# Syar Alexander Valley Instream Mining Project and Sonoma County ARM Plan Amendments

## Response to Comments Document

SCH# 2006042101

Prepared for  
County of Sonoma Permit  
and Resource Management Department

**Figure 3.13-1  
Farmland Sonoma County**

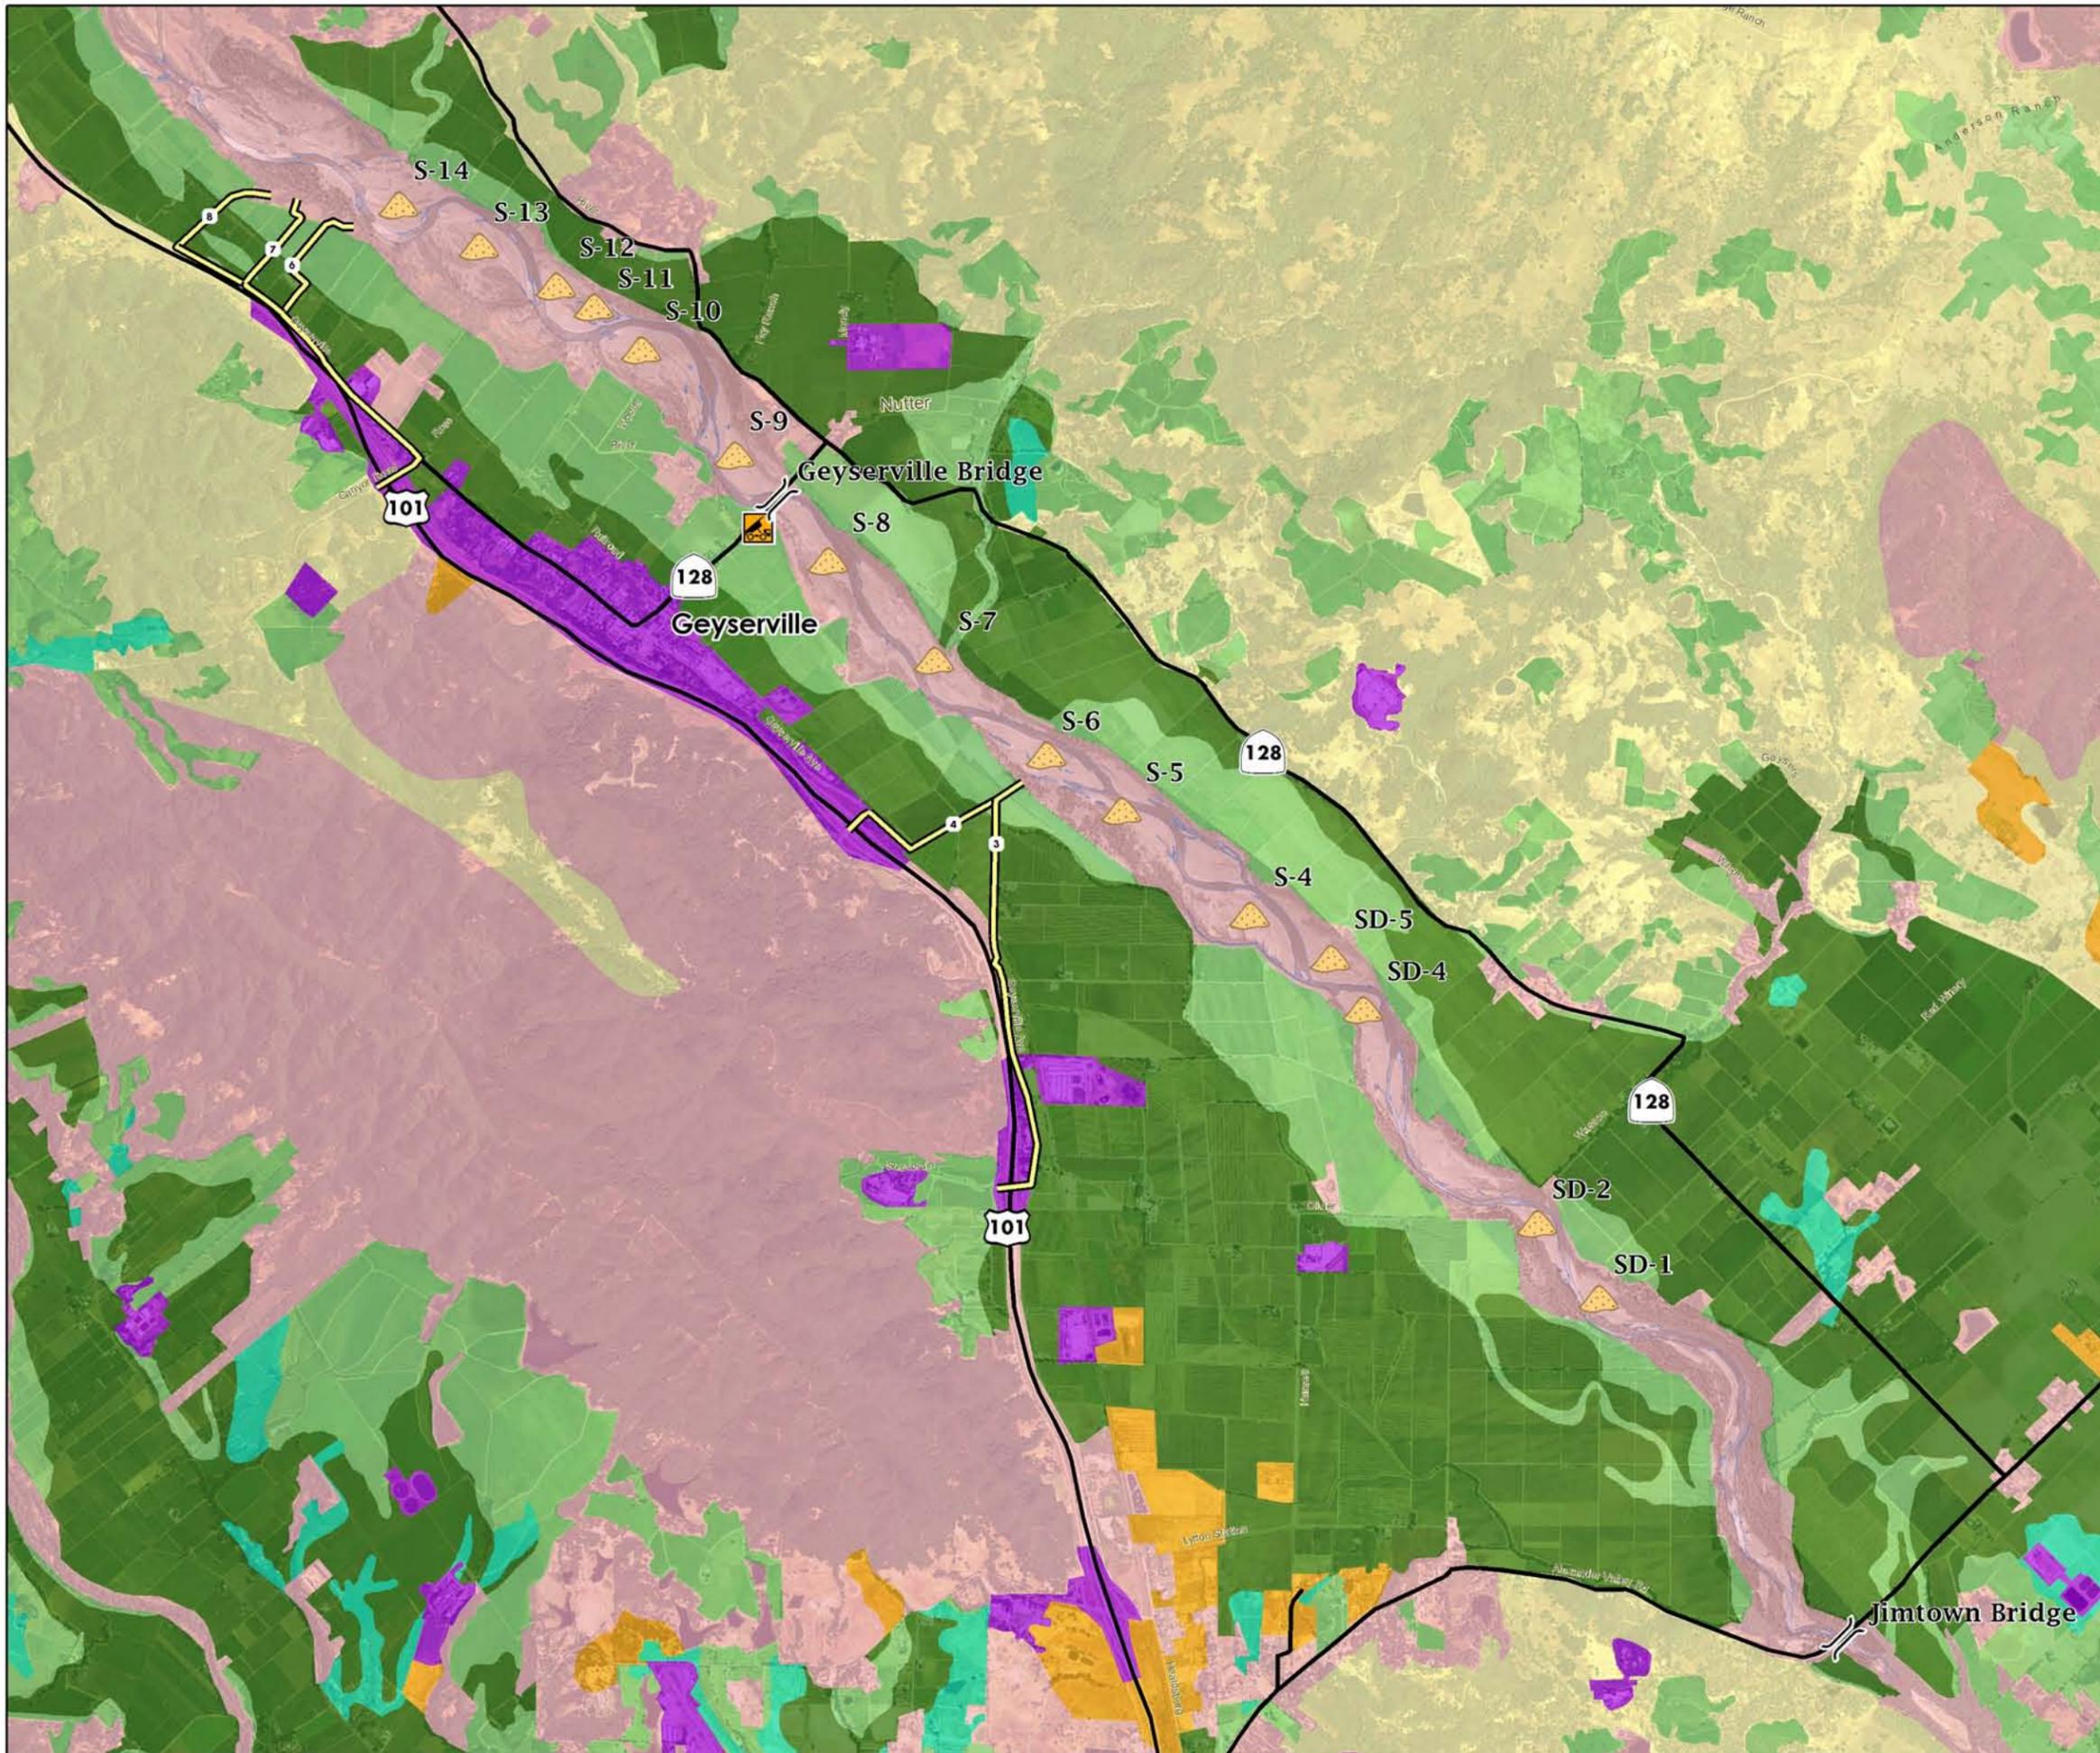
Page 3.13-3 of the Draft EIR, Figure 3.13-1 is revised to reflect the elimination of Haul Routes 2 and 5 from the proposed project.
